Purple Line Briefing

Completed: 02/21/2013

Staff will provide the Planning Board an update on the Purple Line, Capital Crescent Trail, and Silver Spring Green Trail Projects, including:

Exhibit 1: Access Points to Purple Line Station

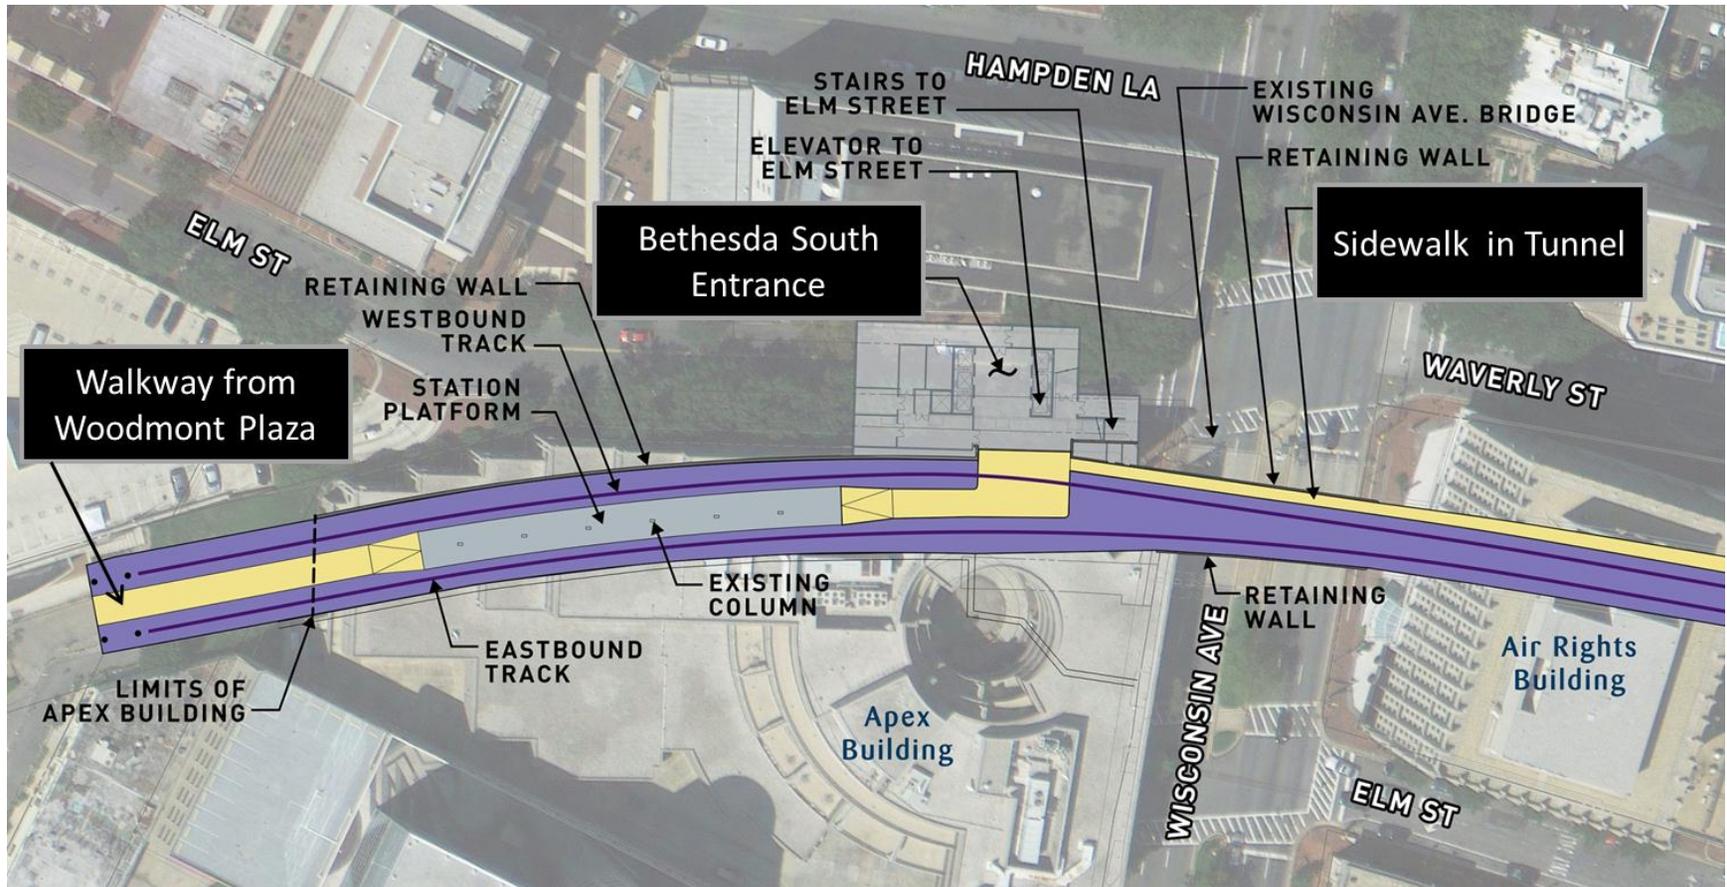
- Sidewalk in the Tunnel: At the request of the community, MTA evaluated the feasibility of a narrow 5 to 7-foot sidewalk on the north side of the Purple Line tracks between the Capital Crescent Trail just east of Pearl Street and the station platform. **This sidewalk is feasible and is included in the Purple Line concept plans.**

Exhibit 3: Plan View of Woodmont Plaza and Fan House

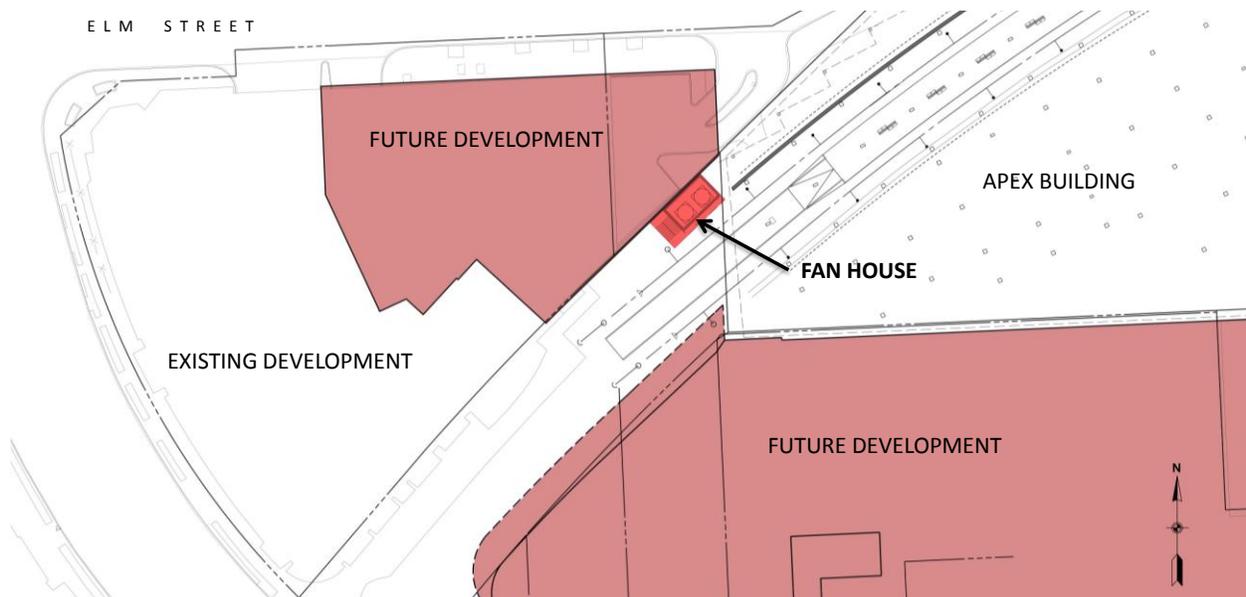
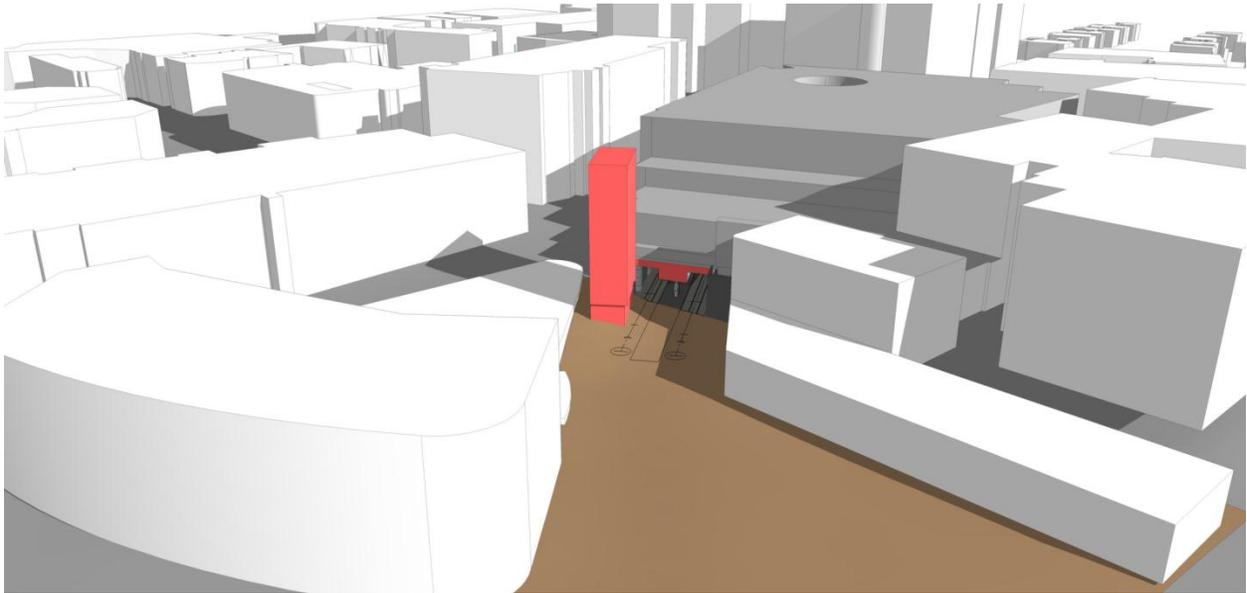
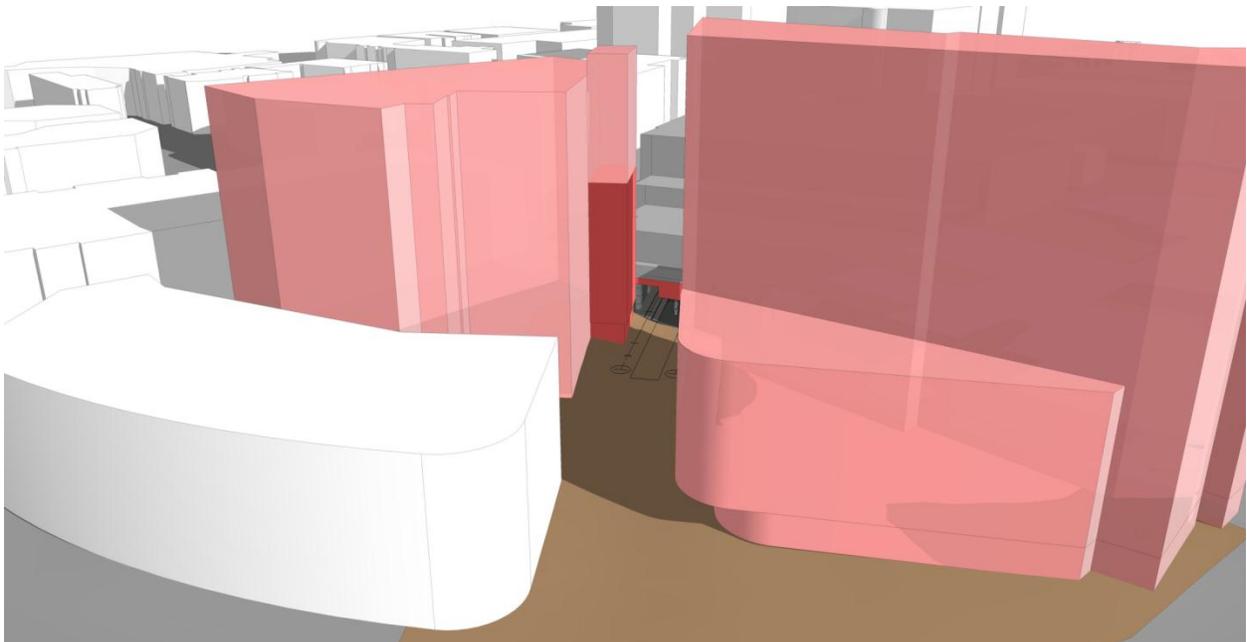
While there are many ways that MTA can mitigate the impact of the fan house in the Woodmont Plaza, its location in a public plaza is not ideal. Planning staff has asked MTA to develop concepts for a potential future location (or relocation) of the fan house for consideration in the update to the Bethesda CBD Sector Plan.

MTA is continuing the discussion about the location of the fan house with Federal Realty and plans to begin working on architectural treatments with the community in the coming months.

Exhibit 17: Silver Spring Green Trail at Wayne Avenue & Cedar Street

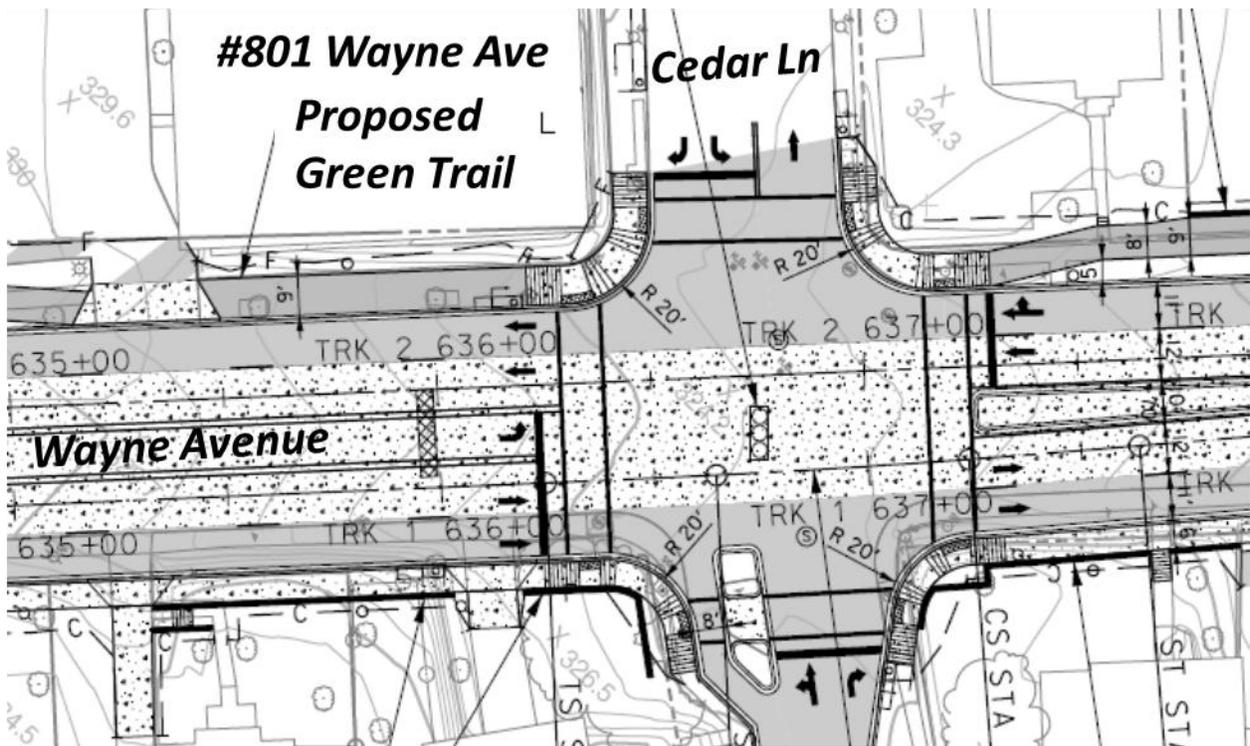
In addition, the intersection of Wayne Ave and Cedar Street is particularly problematic for cyclists (see Exhibit 17). Crossing Cedar Street requires cyclists to make four right angle turns, negotiate four ramps, cross a street, and avoid pedestrians. This does not create an experience that matches the importance

of this trail. And because of this, it is likely that many cyclists will ride against traffic in Wayne Avenue to cross Cedar Street. While there is limited right-of-way available to better accommodate the trail crossing, there may be some space along the frontage of #801 Wayne Ave. It appears that the stairs to this building were constructed in the public right-of-way. If the stairs were removed, it may be possible to shift the trail away from the road and to improve the crossing. This issue will need to be evaluated in greater detail to better understand if and how the staircase was approved in the public right-of-way. If this encroachment was not approved, the County could consider removing it, which might allow the trail to be shifted away from the road and provide a better crossing.

Exhibit 18: Purple Line Tunnel, Portal, and Street Sections on Arliss Street

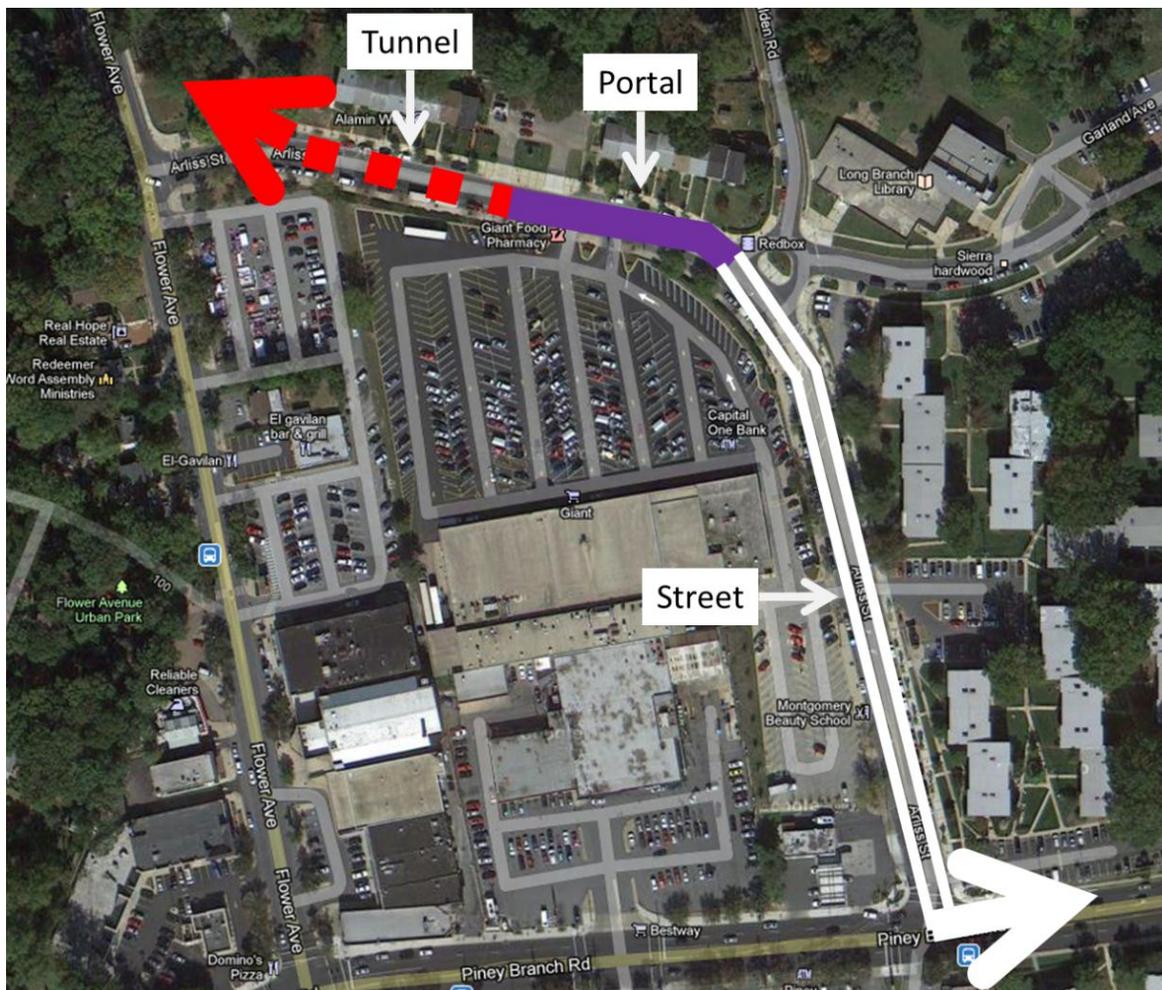
MTA’s proposed alignment along Arliss Street assumes that most of the right-of-way is acquired from the Town Center (Site 1) side of the road. The proposed encroachment ranges from 25 to 50 feet. WRIT is also concerned about the proposed access point to their site at a future signalized intersection at Arliss Street and Garland Avenue at the Long Branch Library. They would prefer to shift the signalized intersection to the north side of the Long Branch Station location. This would either require an additional traffic signal or would require relocating Garland Avenue.

Planning staff has asked MTA to investigate ways to reduce the encroachment into the Town Center. For example, MTA is proposing to provide on-street parking on the north and east sides of Arliss St. This parking is currently heavily used, especially by residents. But in the ultimate condition recommended by the Long Branch Sector Plan the on-street parking is replaced by a parking garage. If the on-street parking does not need to be located on the north and east side of the road when the Purple Line is constructed, it could free up an additional 8 ft in the Town Center. Therefore, staff has asked MTA to look at arrangements that do not require parking on the east side of the road. One possibility may be to shift the parking from the east side of the road to the west side of the road, between Garland Ave and Piney Branch Rd. During the construction of the Town Center when a parking garage is provided, the on-street parking would be removed.

Exhibit 19: MTA's Proposed Access to Long Branch Recreation Center and Pool (From Eastbound Direction)

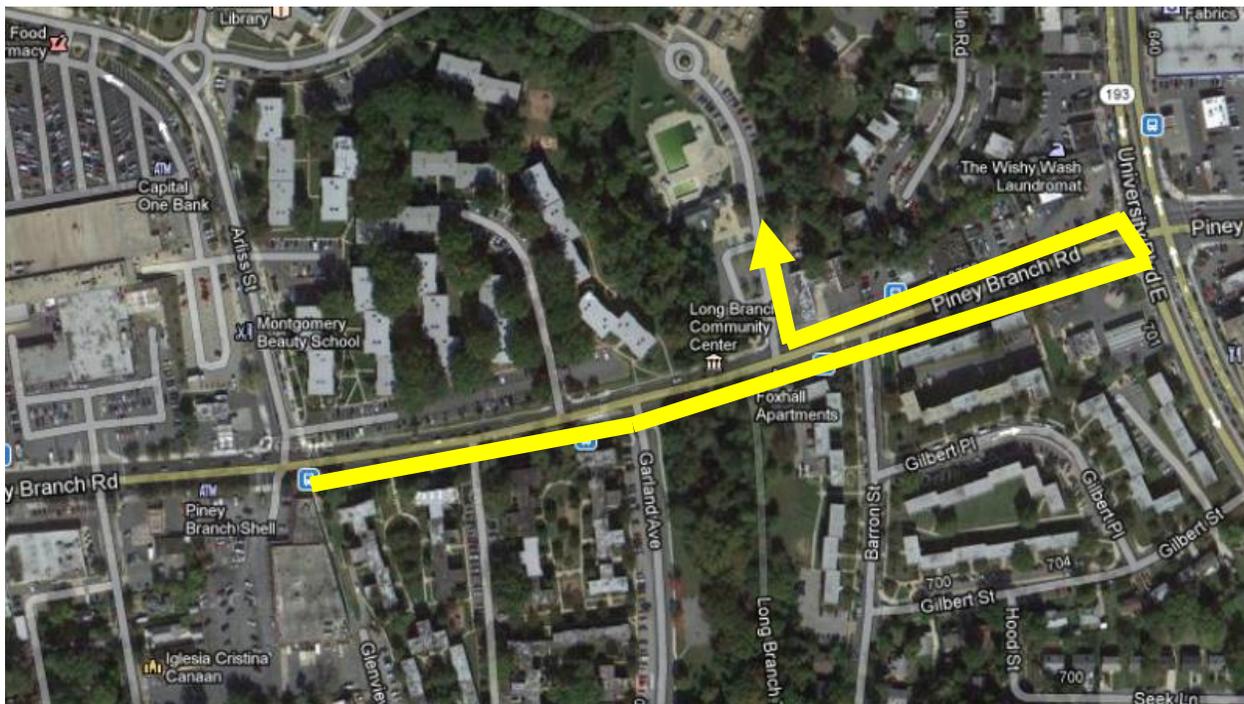
Exiting vehicles headed in the eastbound direction would have to make a right onto Piney Branch Road, make a U-turn at Greenwood Avenue, and then head in the eastbound direction on Piney Branch Road (see Exhibit 20). Of the two access restrictions, the proposed replacement of the entering left turn with a U-turn at University Blvd is the most concerning.

M-NCPPC staff contends that these intersections will be complicated enough post-Purple Line and post-plan implementation and we should not make the intersections even more complicated by encouraging U-turn movements. In addition, the U-turn concept at the intersection of Piney Branch Road and University Blvd is incompatible with the proposed congestion relief strategy proposed in the Long Branch Sector Plan. This strategy would relocate left turns from eastbound Piney Branch Road to northbound University Blvd to the access road proposed at the southwest corner of the intersection.

MTA has been asked to explore three options to allow full turning movements into and out of these facilities in the Long Branch Sector Plan Public Hearing Draft (page 33). These include:

1. Align the driveway of the Long Branch Pool and Recreation Center with Barron Street and also add a new left turn lane for eastbound traffic along Piney Branch Road.
2. Widen and improve the new Long Branch Pedestrian Bridge to allow vehicular access to the Long Branch Pool and Recreation Center from Arliss Street.
3. Develop preliminary concepts and cost estimates to relocate the Long Branch Pool and Recreation Center to a new public facility campus on the west side of the Long Branch Stream Valley, at the current site of the Long Branch Library.

Exhibit 21: Fourth Access Option to Long Branch Pool and Recreation Center

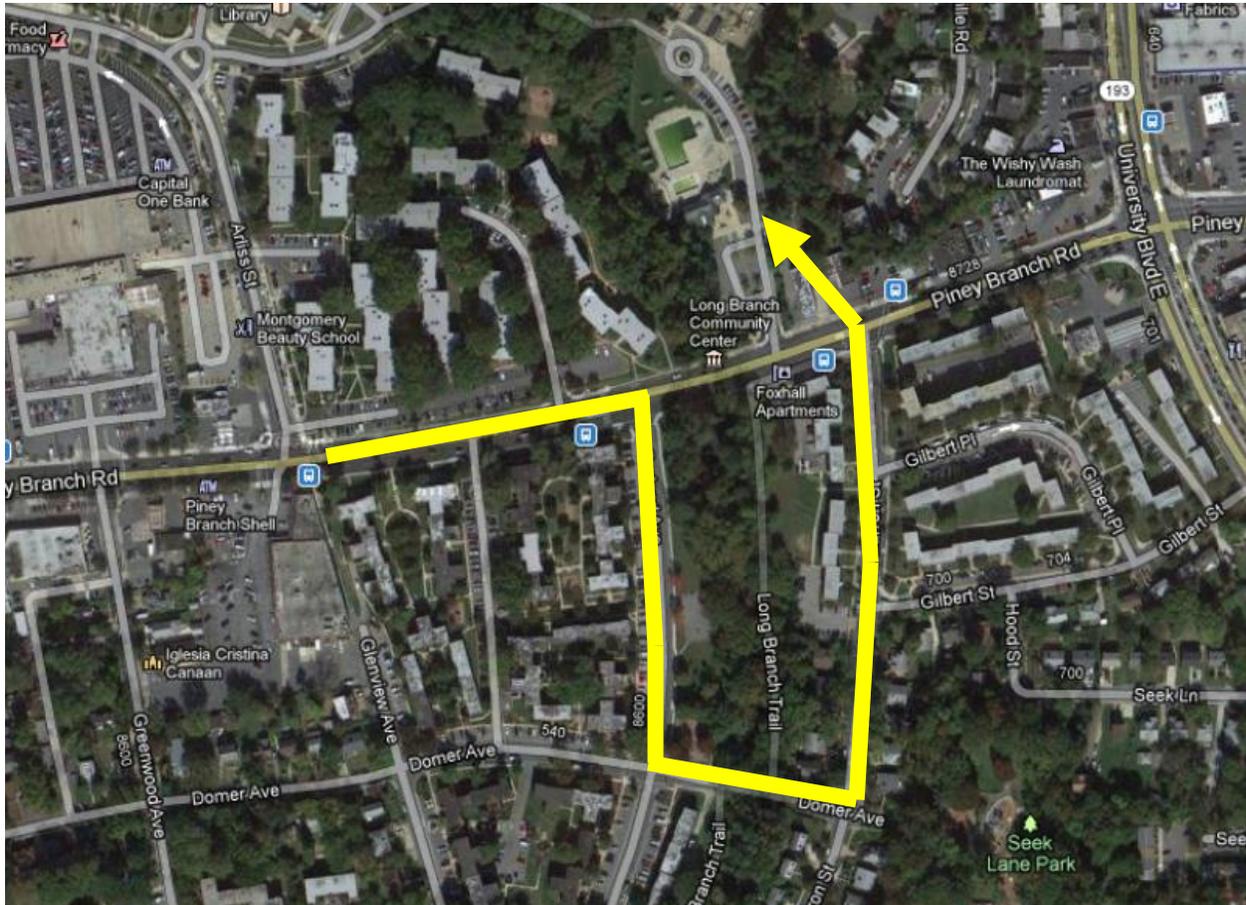
There is also a potential fourth option – a variation of option 1 – that instead of adding a new left turn lane for eastbound traffic would instead route visitors through south on Garland Ave, across the proposed Domer Ave multimodal bridge, and north on Barron St (see Exhibit 21).
